Title - Sujet Roof Replacement	
Solicitation No. - N° de l'invitation F1700-150961/A	Amendment No. - N° modif. 002
Client Reference No. - N° de référence du client	Date 2016-01-22
GETS Reference No. - N° de référence de SEAG PW-\$PWY-005-7711	
File No. - N° de dossier PWY-5-38349 (005)	CCC No./N° CCC - FMS No./N° VME
Solicitation Closes - L'invitation prend fin at - à 02:00 PM on - le 2016-01-29	
Time Zone Fuseau horaire Pacific Standard Time PST	
F.O.B. - F.A.B. Plant-Usine: <input type="checkbox"/> Destination: <input checked="" type="checkbox"/> Other-Autre: <input type="checkbox"/>	
Address Enquiries to: - Adresser toutes questions à: Pillay, Sal (PWY)	Buyer Id - Id de l'acheteur pwy005
Telephone No. - N° de téléphone (604) 775-9386 ()	FAX No. - N° de FAX (604) 775-6633
Destination - of Goods, Services, and Construction: Destination - des biens, services et construction: DFO - West Vancouver Lab - West Vancouver, BC

Addendum 2

Project No	5437	Date	January 21, 2016
Project	Centre for Aquaculture and Environmental Research ROOF REPLACEMENT 4160 Marine Drive West Vancouver, BC Department of Fisheries and Oceans - West Vancouver Laboratory

A302 Details**Add: Note:**

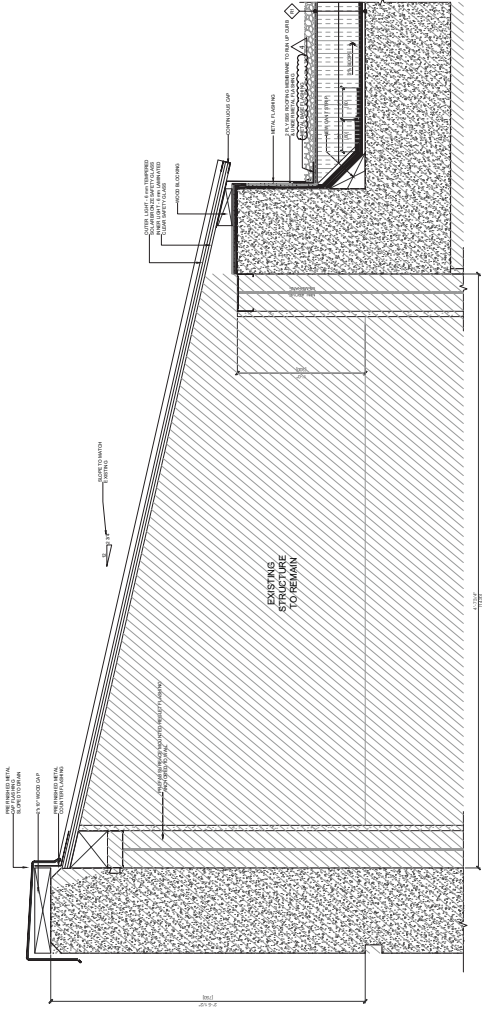
- Metal flashing **and fascia board to be repaired /** reinstalled correctly.
- Metal base flashing
